When consumer experience issues in relation to SSB/software or Android TV usage on 2K14 Marvell product, upgrade to newer technology 2K16 MTK5593 F platform is now available.

Affected Chassis: QV14.1E LA

Info: Upgrade 2K14 Marvell platform hardware to 2K16 MTK593 F platform. Before does it please get customer approved first. If the consumer/retailer disagree with the solution to upgrade his set please proceed with normal repair (original Marvell SSB boards remain available and listed in the BOM of /12 & /60).

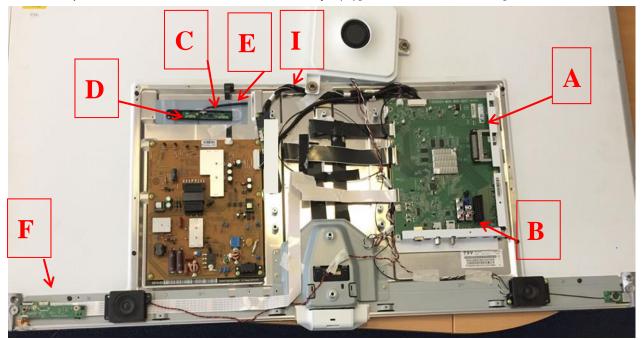
Confirm if customer would like to update the TV and record the consumer communiqué. (Refer to CCBTPV369) and follow the normal repair process.
